RESOLUTION NO. 540

A RESOLUTION OF THE CITY COUNCIL OF THE CITY OF REDMOND, WASHINGTON, APPROVING THE PRELIMINARY PLAT AND PLANNED UNIT DEVELOPMENT OF BEAR CREEK MEADOW (PP-7911/PUD #35) AND APPROVING THE HEARING EXAMINER'S RECOMMENDATIONS.

File No. PP-79-11/PUD#35  
Bearcreek Meadow

Attachment "B"

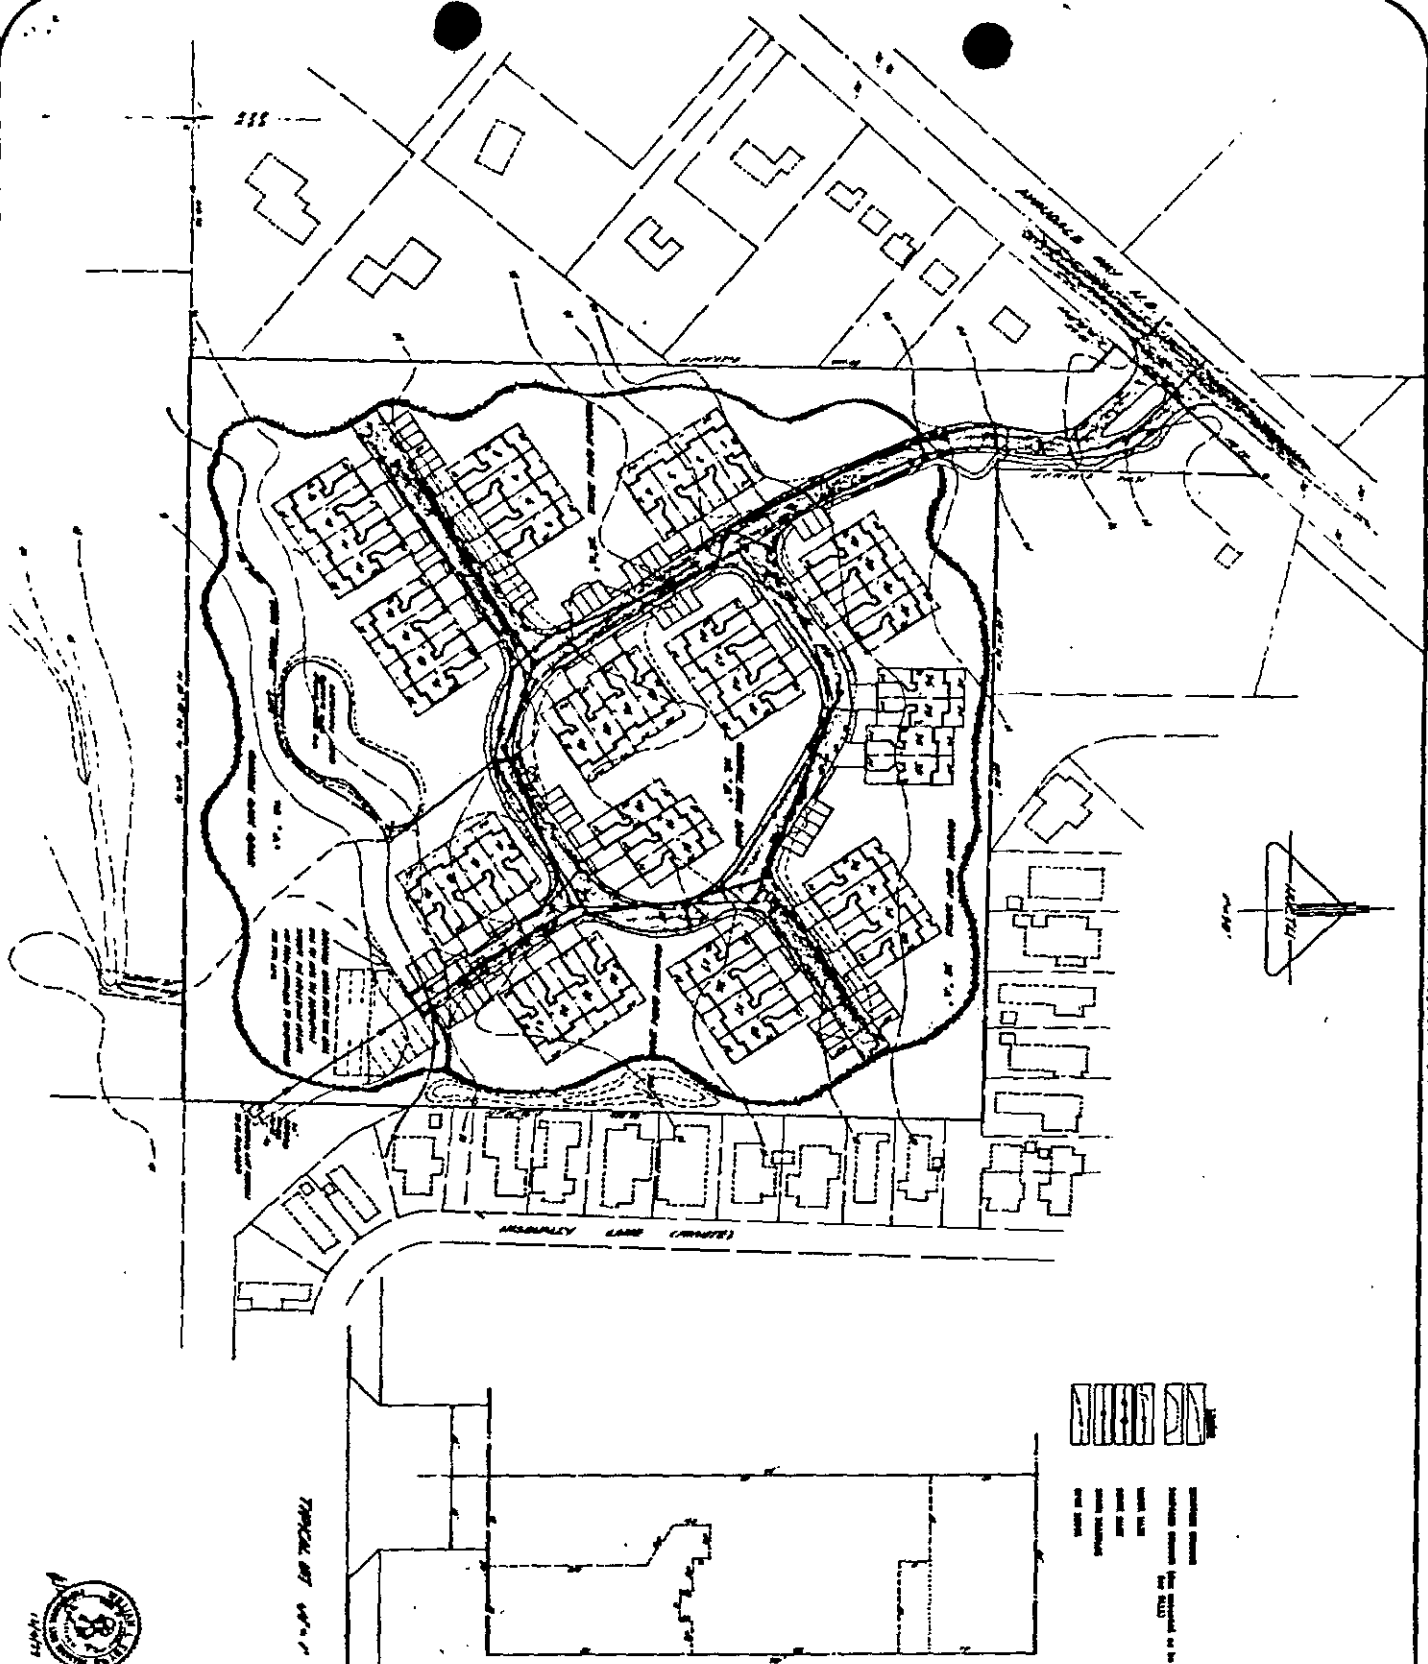
5. Access to the proposed development will be from Avondale Road as shown on Attachment "B."
6. Although a small portion of the southeast corner of the site is on a 100-year plain, no development is proposed on this portion of the area. The site contains no other development limitations and is in compliance with the goals and policies of the City of Redmond.
